System Characterization Work Plan Part 1 (QAPP)
System Characterization Work Plan Part 2 (QAPP)
and
NJDEP approval letters dated October 20, 2016

Re: Receipt of Amended Sewer System Characterization Work Plan Part 1
PVSC, NJPDES Permit No. NJ0021016
Paterson City, NJPDES Permit No. NJ0108880
Newark City, NJPDES Permit No. NJ0108758
Kearny Town, NJPDES Permit No. NJ0111244
Harrison Town, NJPDES Permit No. NJ0108871
East Newark Borough, NJPDES Permit No. NJ0117846

**SYSTEM CHARACTERIZATION AND
LANDSIDE MODELING PROGRAM
QUALITY ASSURANCE PROJECT PLAN (QAPP)
PART 1**

Re: Technical Comments on the Sewer System Characterization Work Plan Part 1
Borough of East Newark, NJPDES Permit No. NJ0117846
Town of Harrison, NJPDES Permit No. NJ0108871
Town of Kearny, NJPDES Permit No. NJ0111244
City of Newark, NJPDES Permit No. NJ0108758
City of Paterson, NJPDES Permit No. NJ0108880
PVSC, NJPDES Permit No. NJ0021016

SYSTEM CHARACTERIZATION SAMPLING AND MODELING PROGRAM
 PVSC SEWER DISTRICT
 FIGURE 1

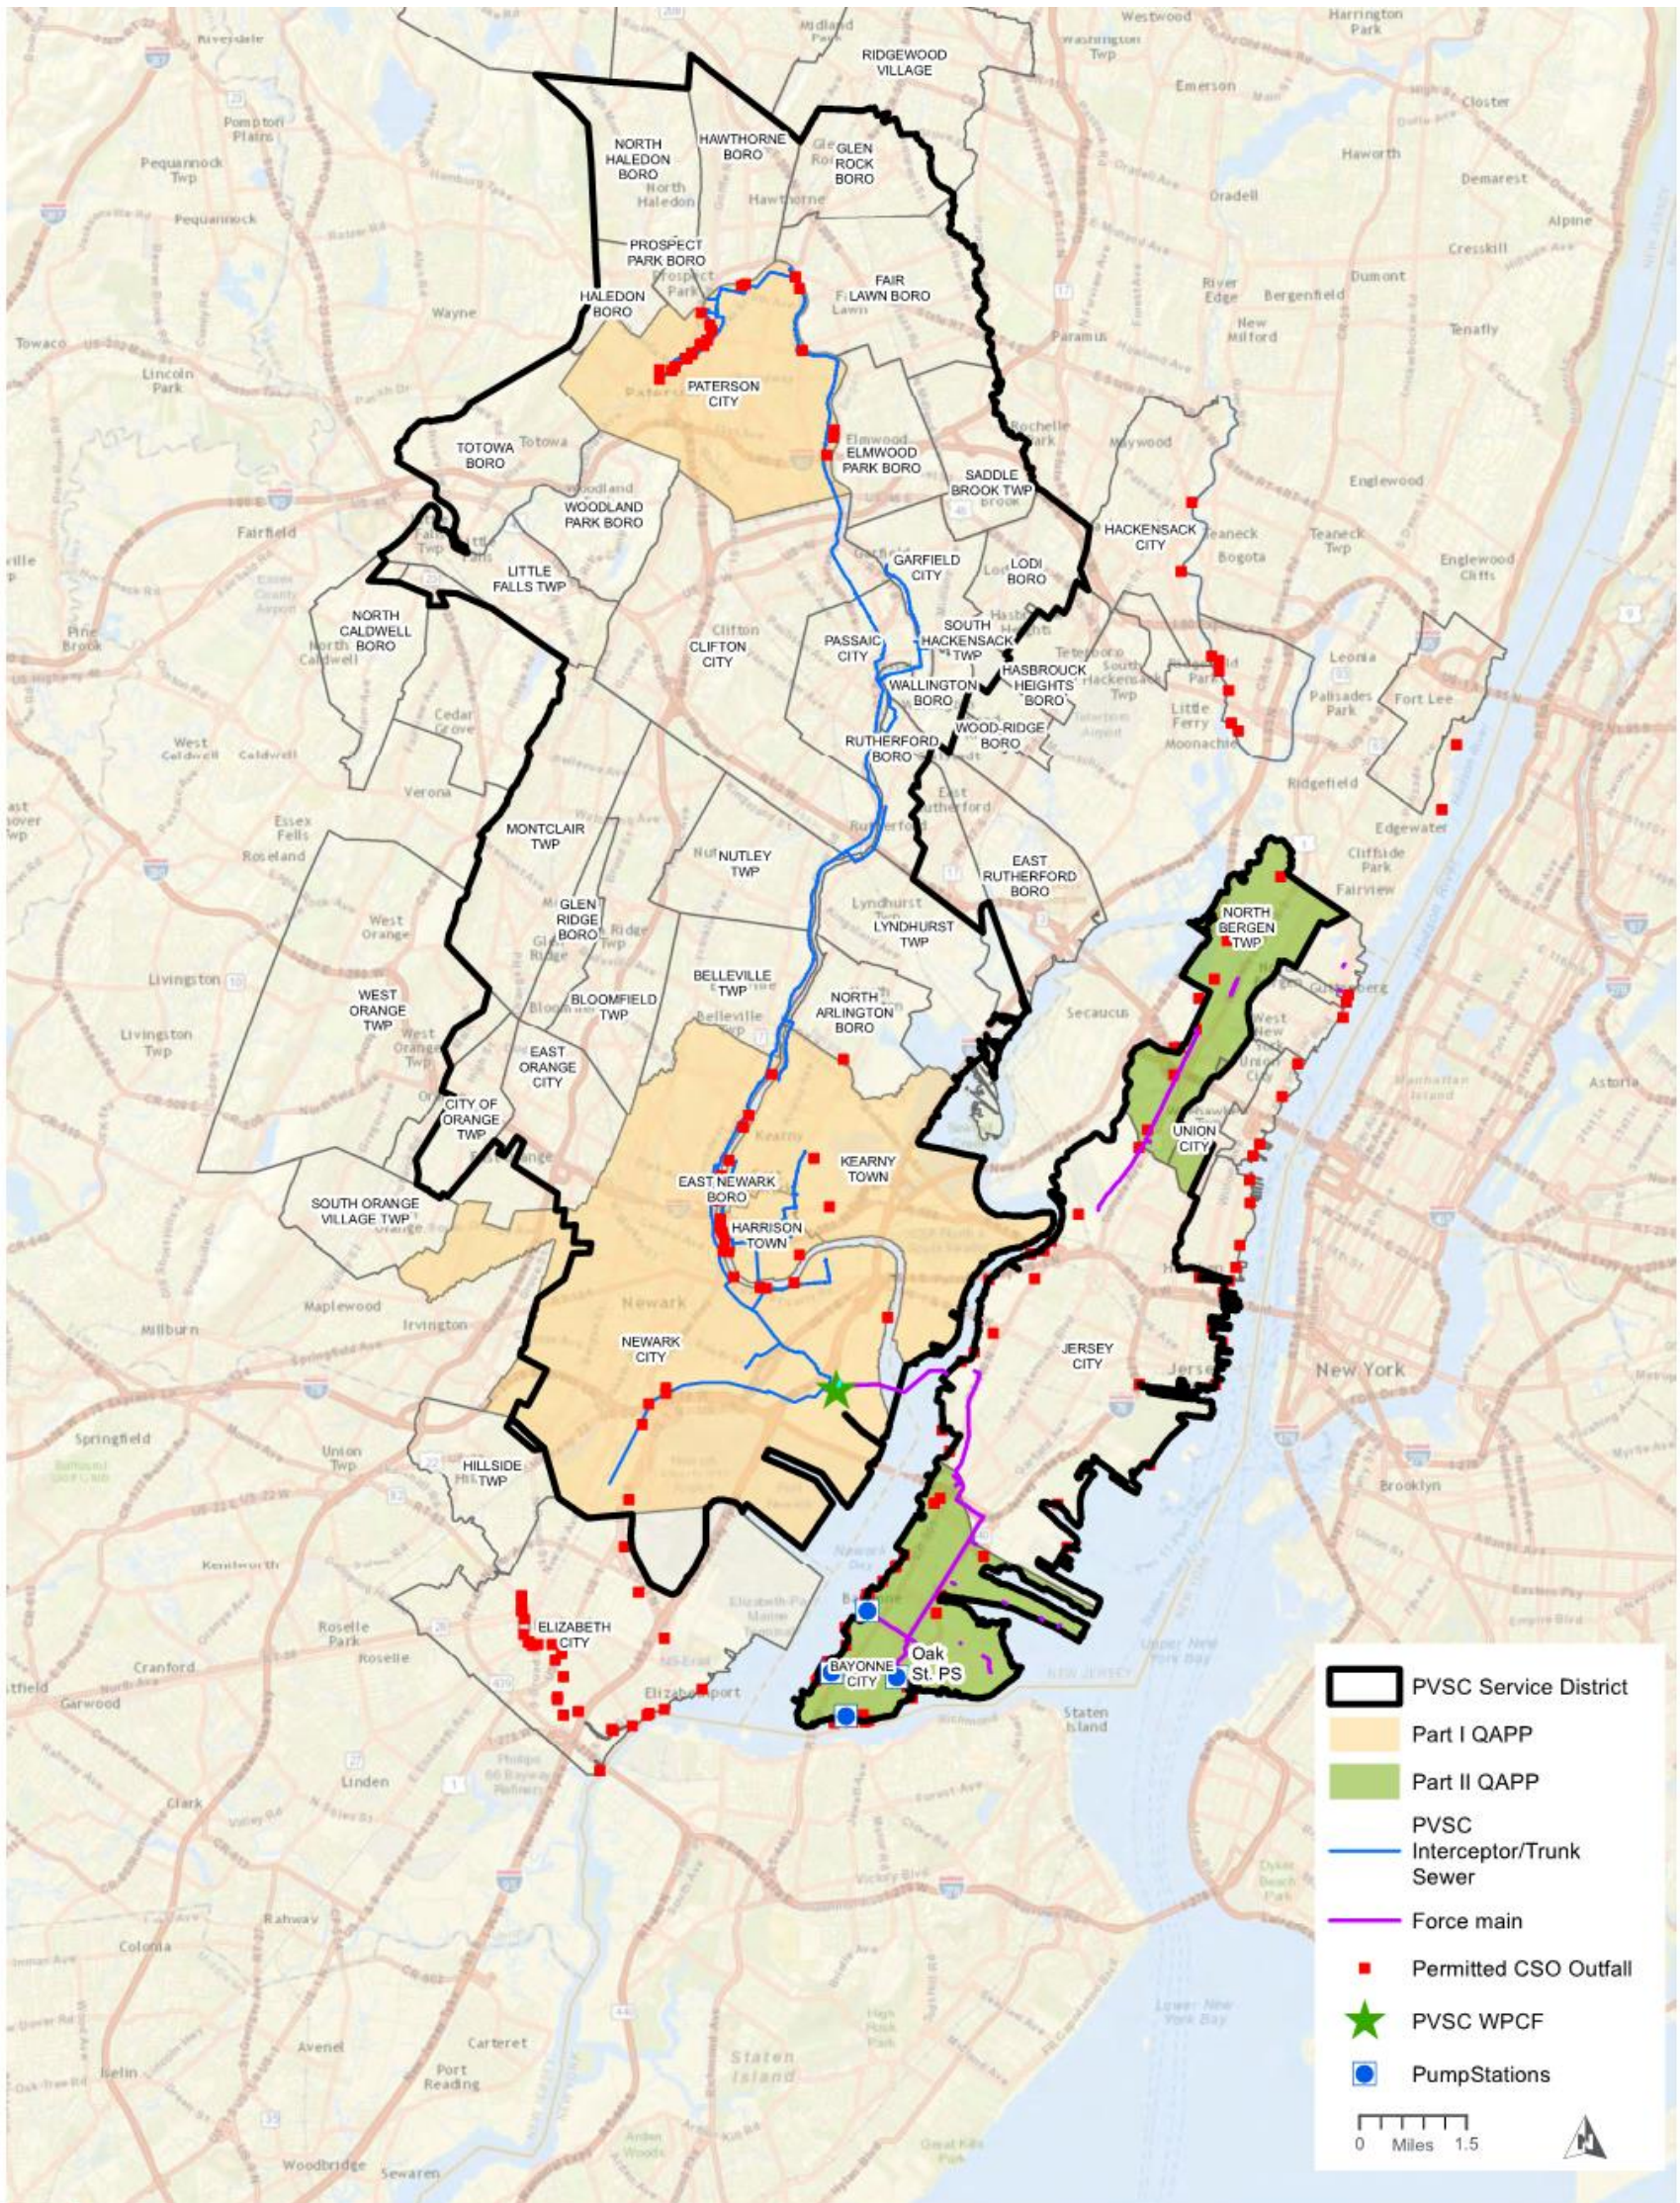
Comment 15: Figure 1 is included on page 18. While force mains are included in the legend, it does not appear that the North Bergen MUA force main is included. Please confirm.

Comment 25: On page 28 you state that the “flow monitoring equipment will be installed in the combined trunk sewer upstream of the overflow chamber...” However, based on Figure 1 there is no differentiation between PVSC Interceptor and the Trunk Sewer. Please clarify.

Figure 3 – Rainfall Volume Probability Plot

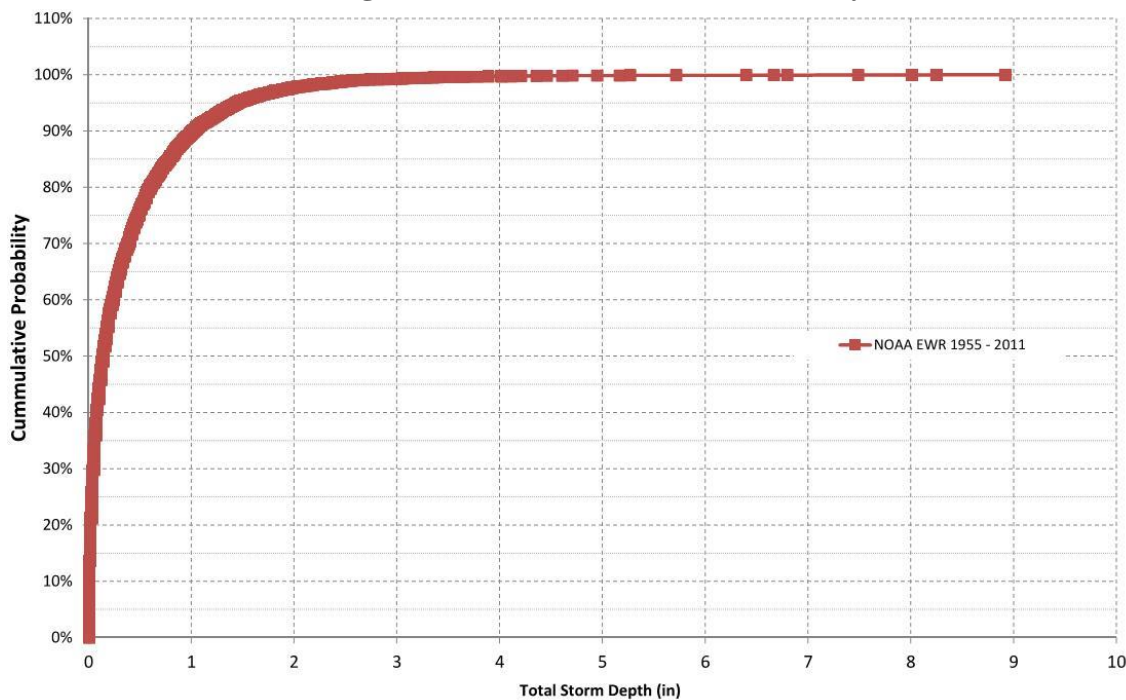
Comment 10: Under the list of figures on page 13, Figure 2 should be listed as “Rainfall Volume Probability Plot” as is indicated on Figure 2.

Figure 4

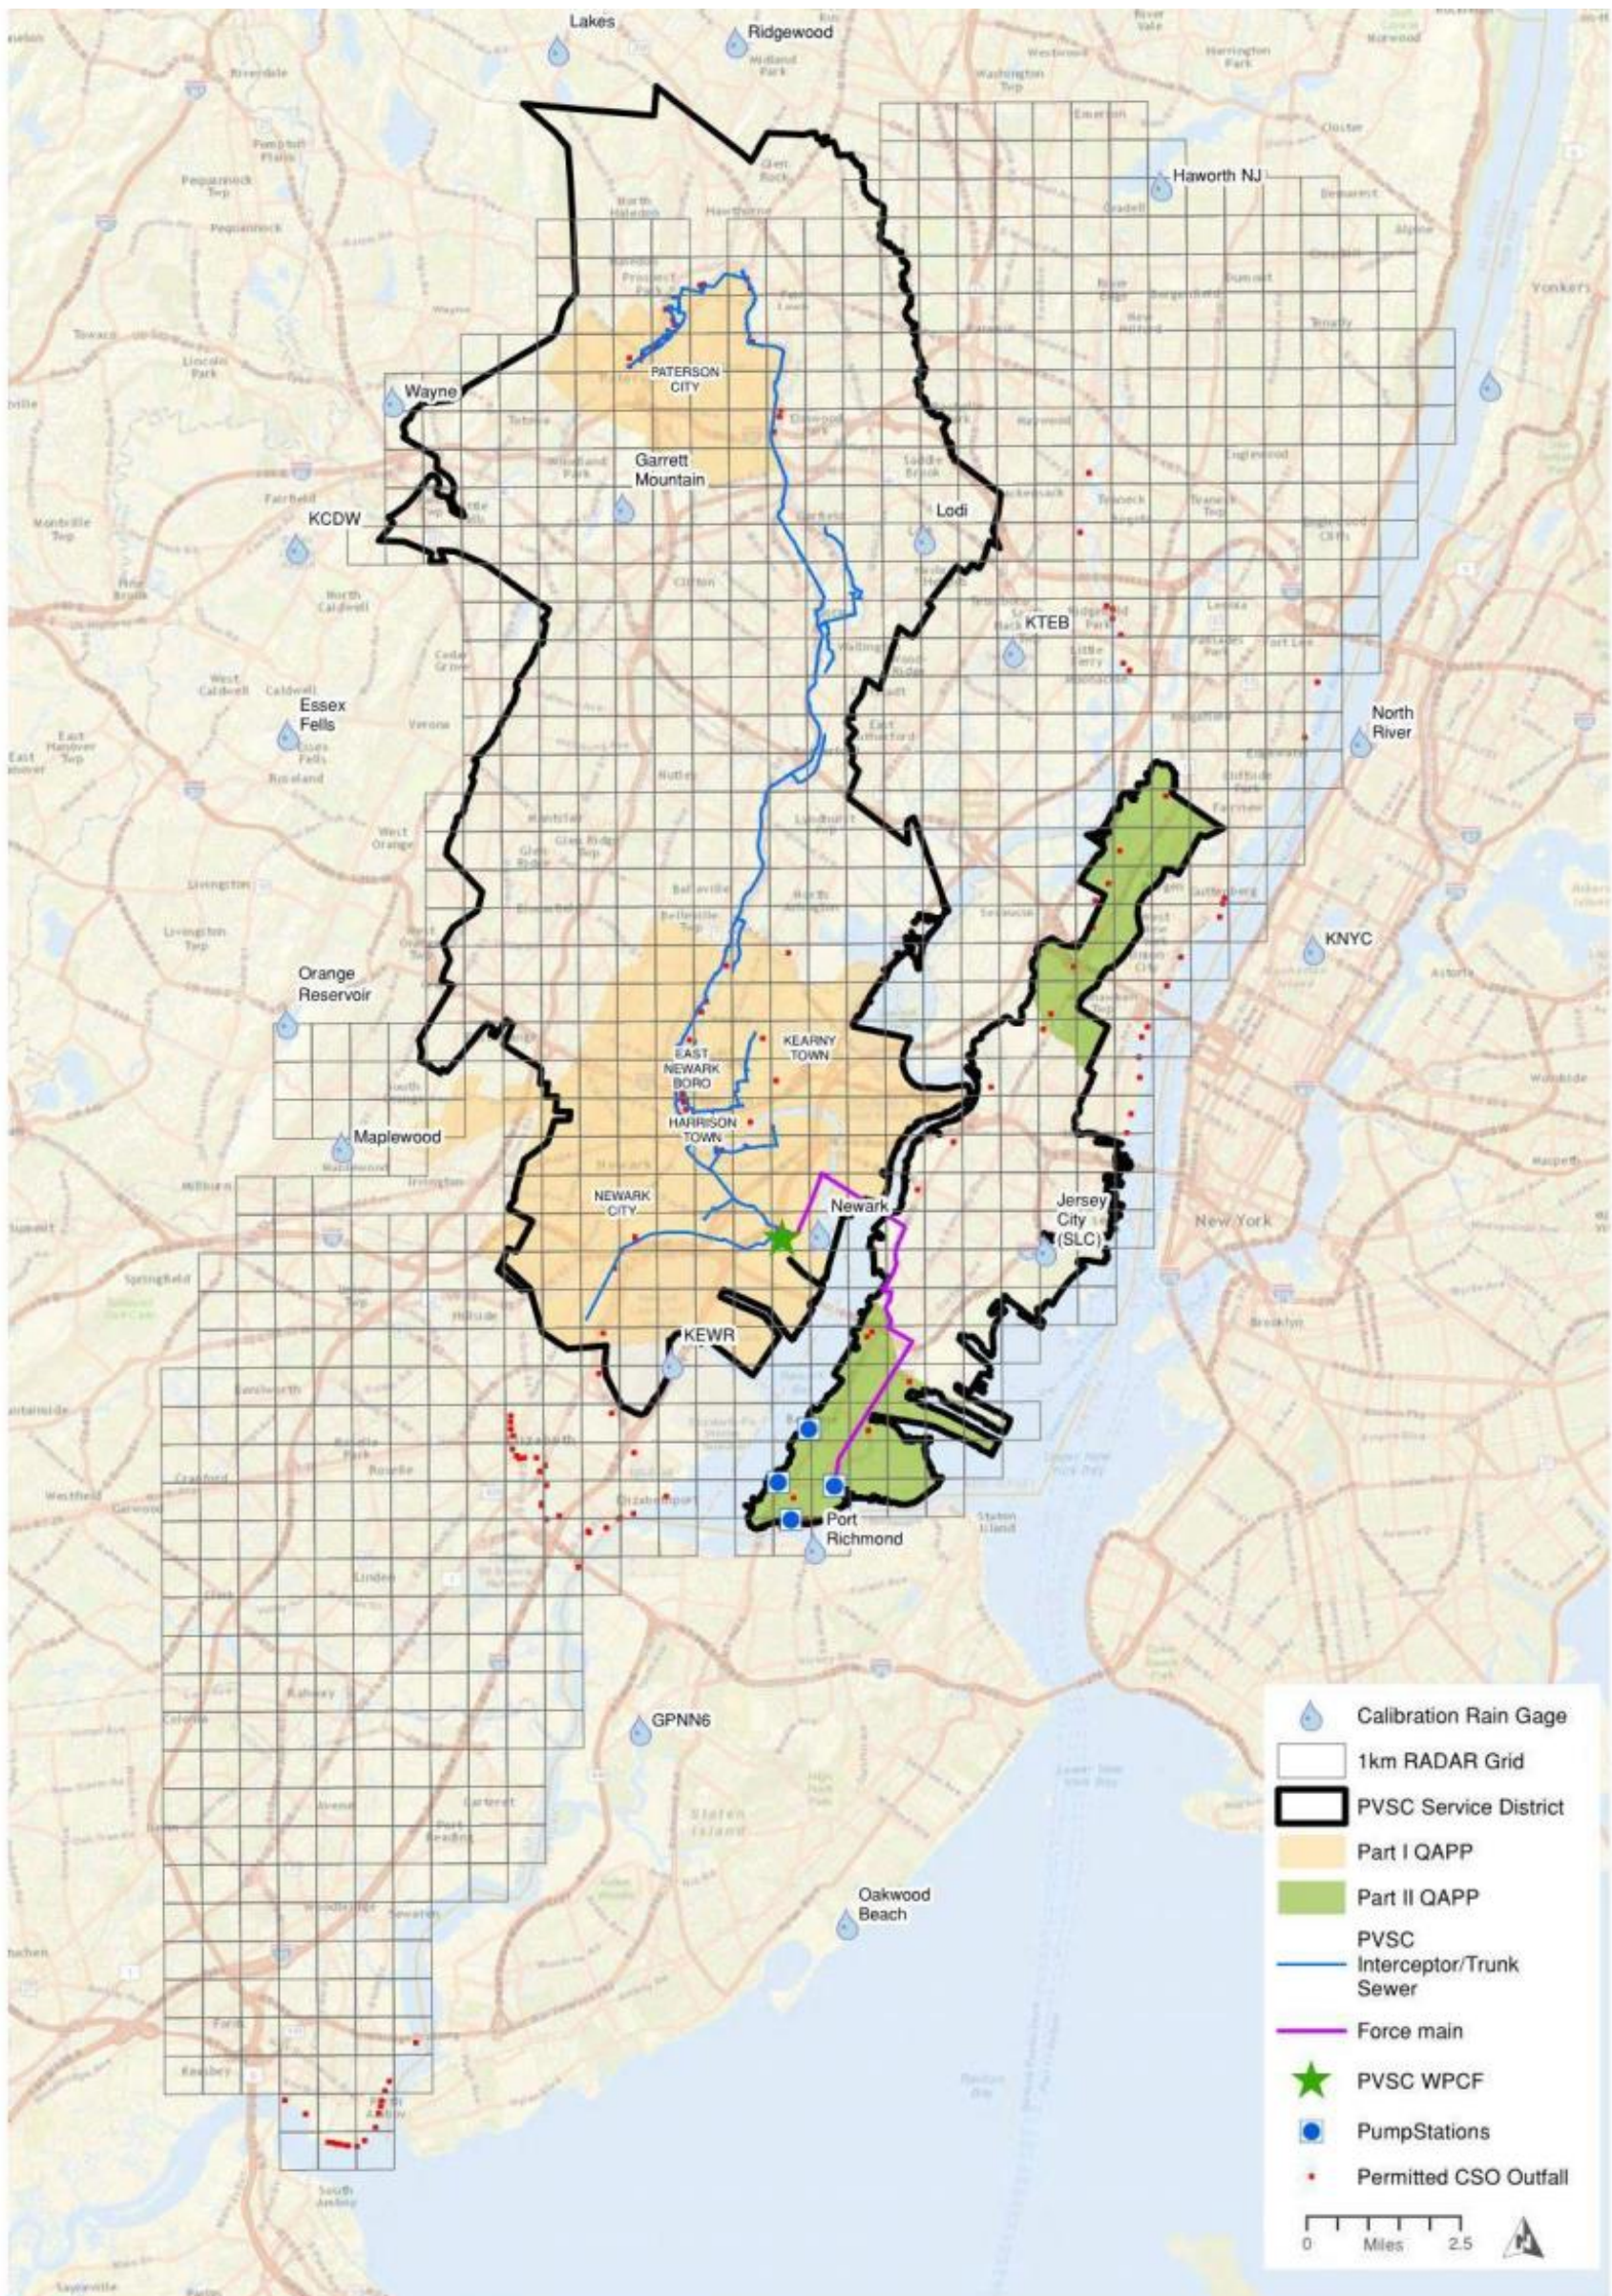
While some regulators are shown on Figure 4, this does not appear to show all of the regulators for Part 1.

Comment 1: Figure 4 indicates that certain pipes will be modeled (shown in green). Please clarify whether each pipe shown will be modeled individually. If not, please indicate on the map the portion of the CSS to be modeled. For example, some permittees establish a pipe diameter threshold size for their model.
